DEPARTMENT OF THE ARMY
U.S. ARMY CORPS OF ENGINEERS
441 G STREET NW
WASHINGTON, D.C. 20314-1000

SUBJECT: Addition to the U.S. Army Corps of Engineers Sign Standards Program –
Approval of New Danger Sign

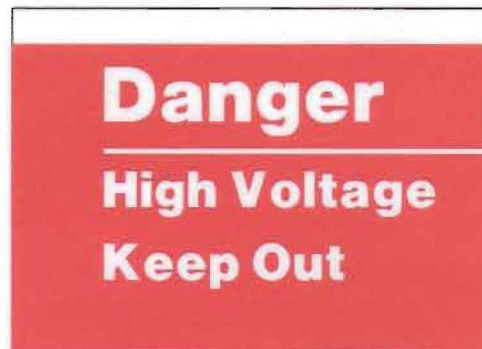
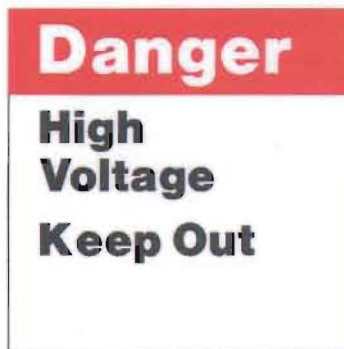
1. Upon the recommendation of the Sign Advisory Work Group and the National Sign Program Manager, safety signs reading **Danger/ High Voltage/Keep Out** have been added to the U.S. Army Corps of Engineers Sign Standards Manual (EP310-1-6a and 6b). The following graphics of the new signs will go into the manual, the Corps SignPro software, and be posted on the Natural Resources Management Gateway at <http://corpslakes.us/sign>.
